Title: ERID-111328 SUBMITTAL OF THE RESPONSE TO THE NOTICE OF DISAPPROVAL FOR THE INVESTIGATION WORK PLAN FOR LOWER PAJARITO CANYON AGGREGATE AREA AND REVISION 1, INCLUDING 2 CD'S, EP2010-0521, EP2010-0522, LA-UR-10-7635

To:(Addressees - Organization) JAMES BEARZI, NMED

From:(Senders - Organization) MICHAEL J GRAHAM, LANL
 GEORGE J RAE, DOE

Figure 4.15-3 Organic chemicals detected at AOC 18-006

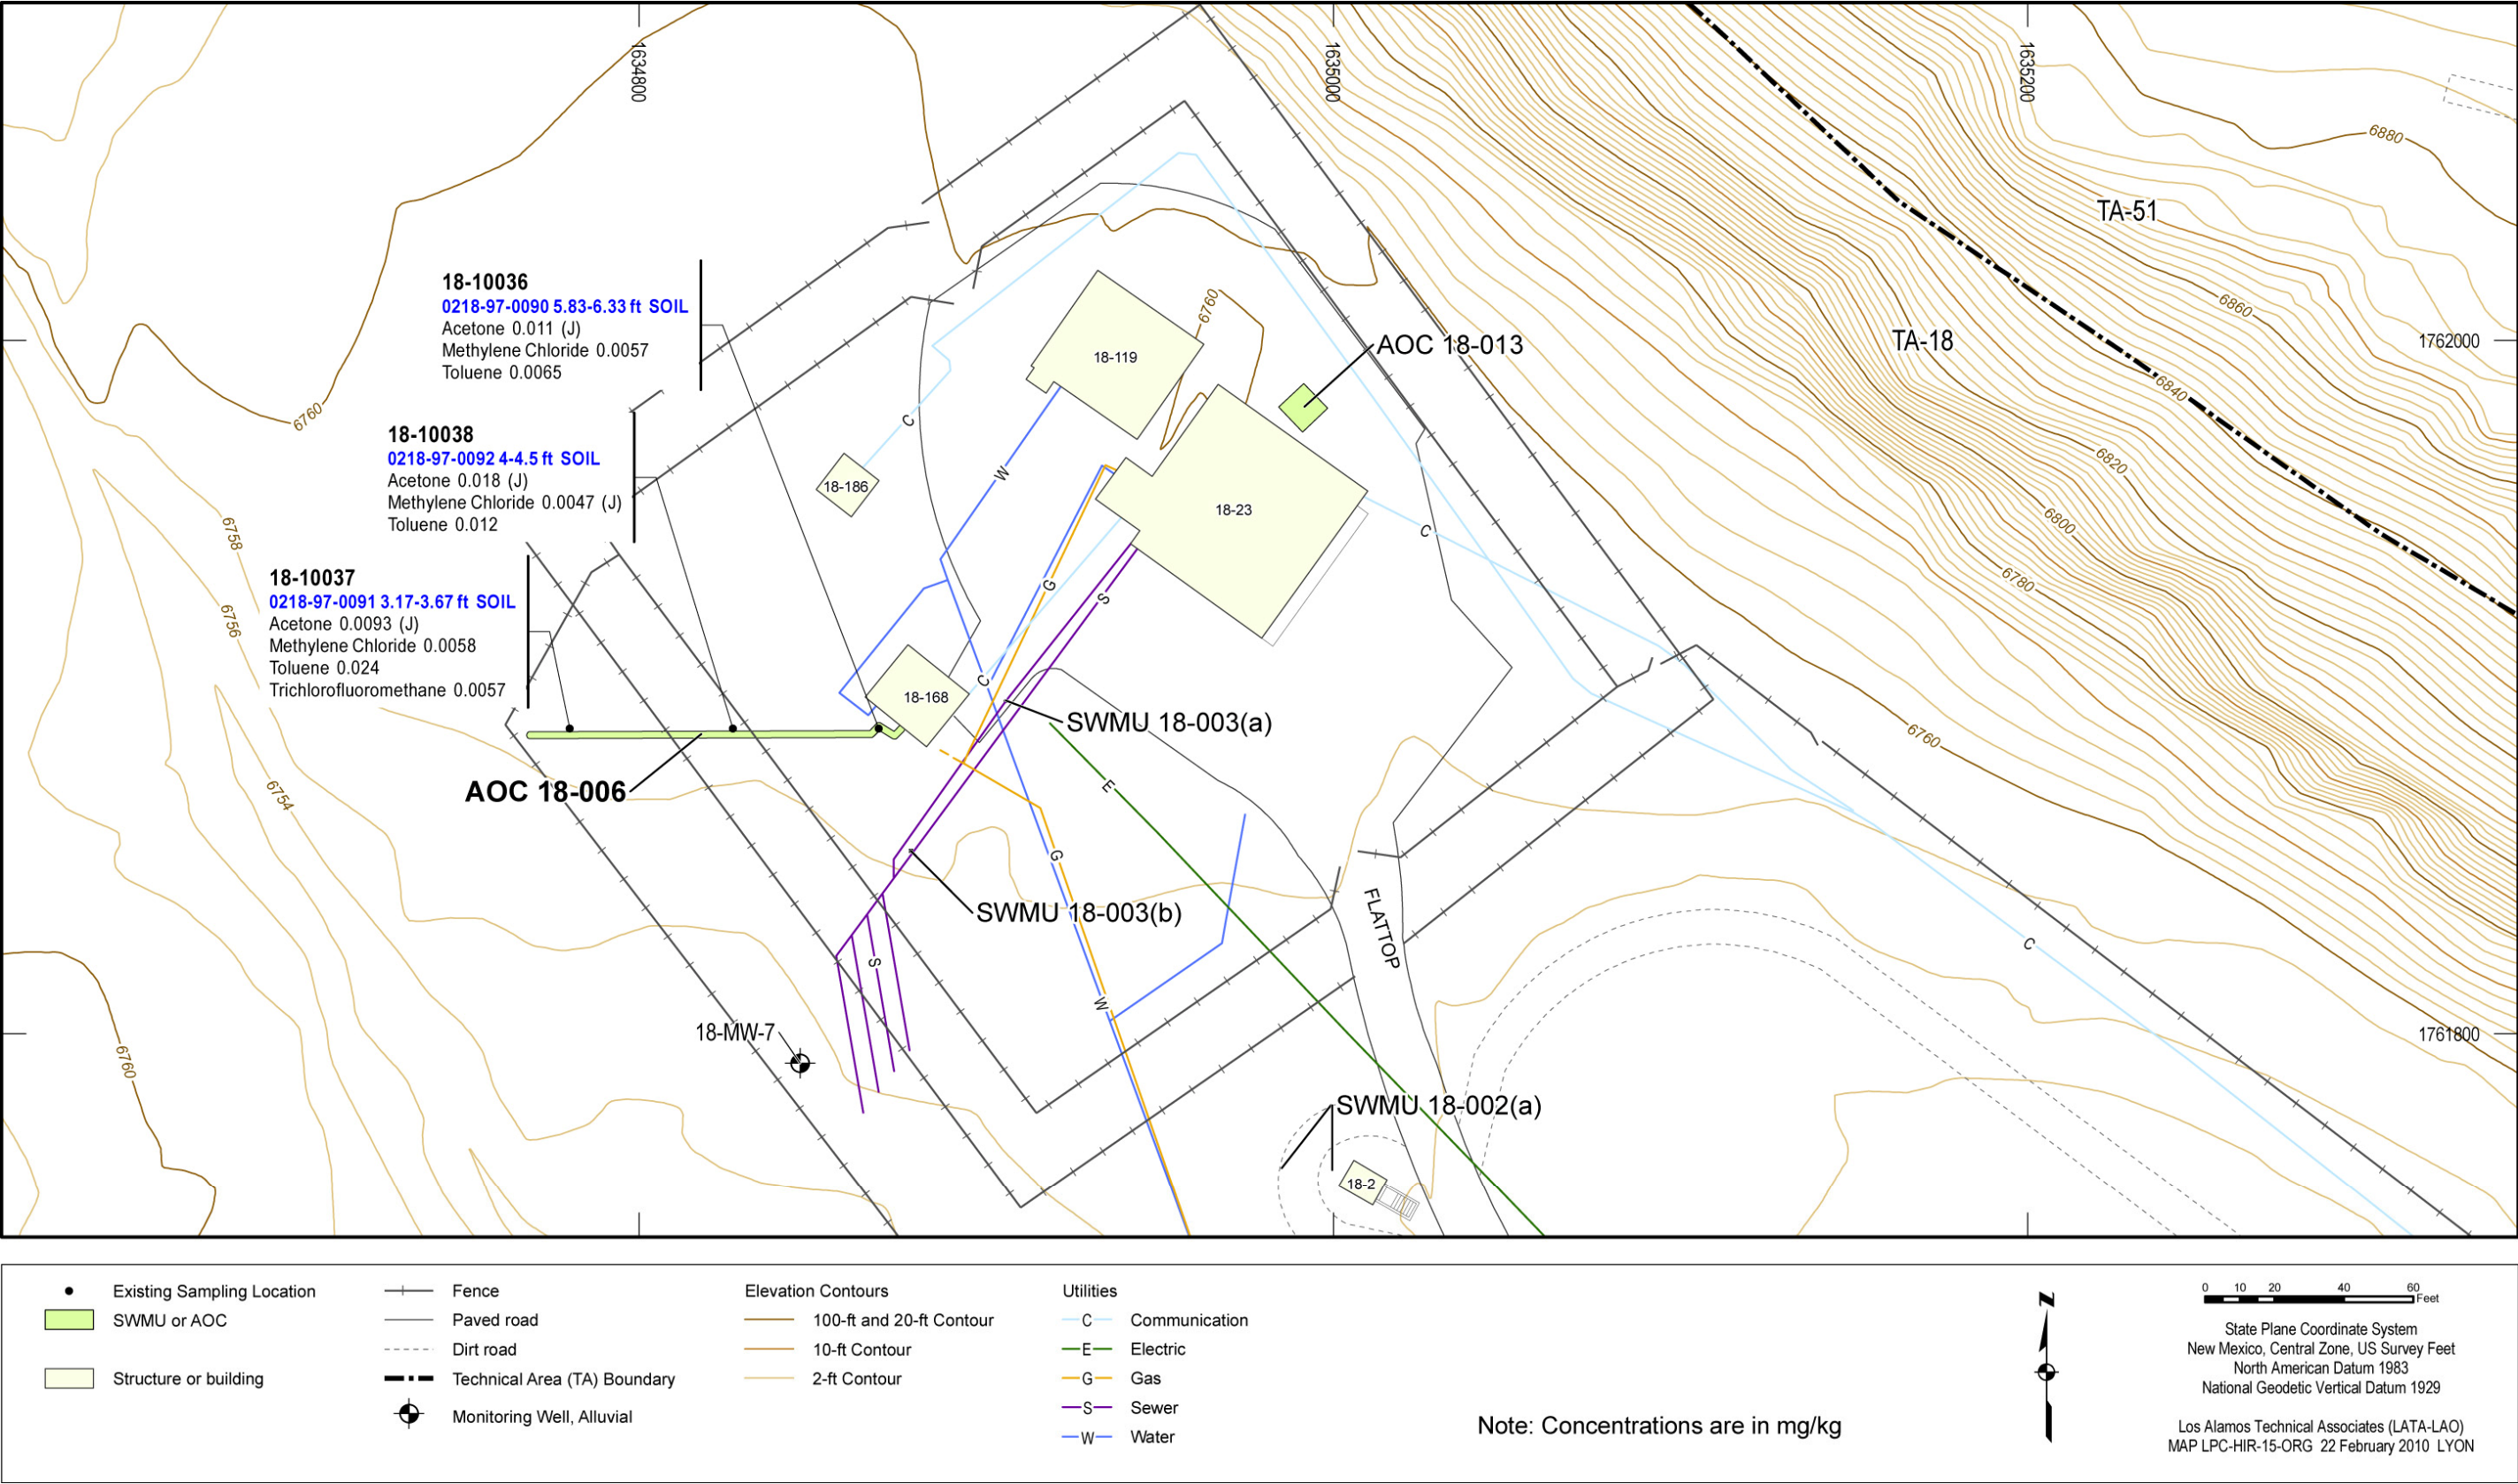
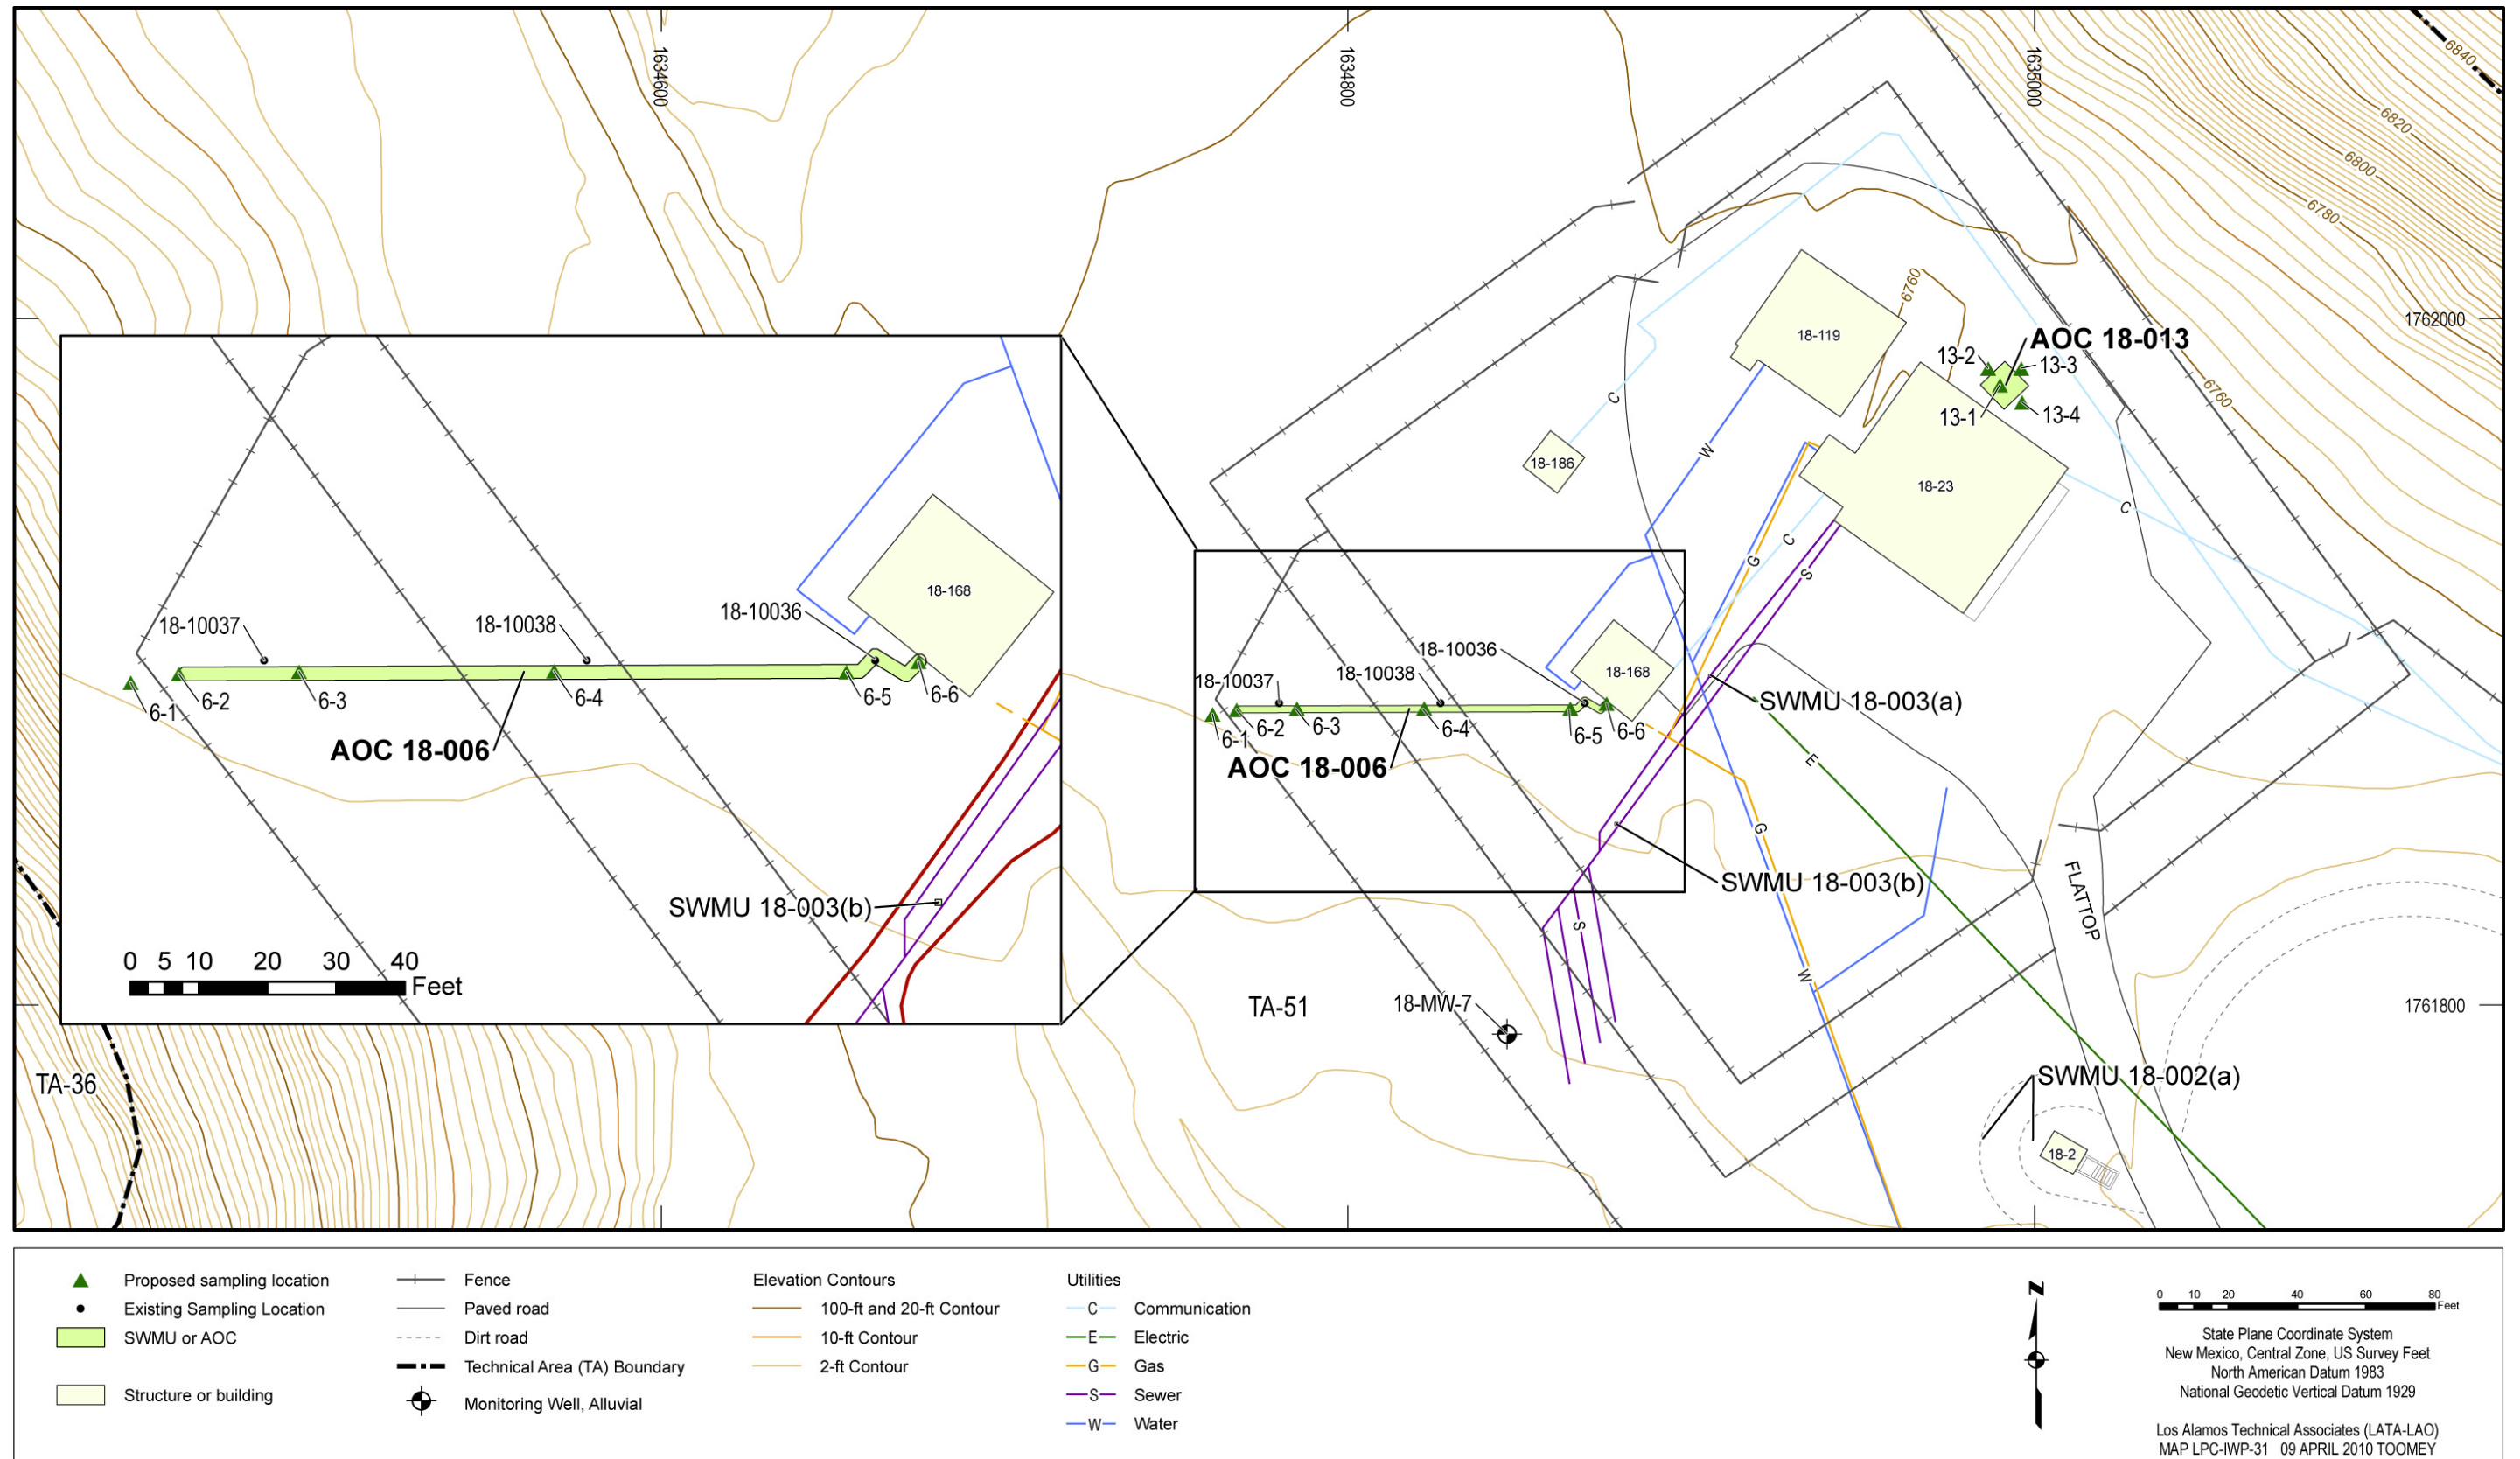
NMED Comment: One well (18-MW-7) is shown on Plan Plate 1. Verify this well is one of the four wells mentioned above. In addition, include all well locations on Plan figures associated with this

27. Well 18-MW-7 is one of the four wells mentioned in section 4.15.1. The well has been added to Figures 4.15-1 through 4.15-4. The other well locations are not included on the plan figures because they are located 1100 ft downgradient of AOC 18-006, beyond the depicted map area. The text in section 7.4 has been revised to state what measures will be taken in the event that groundwater is encountered while advancing the boreholes.
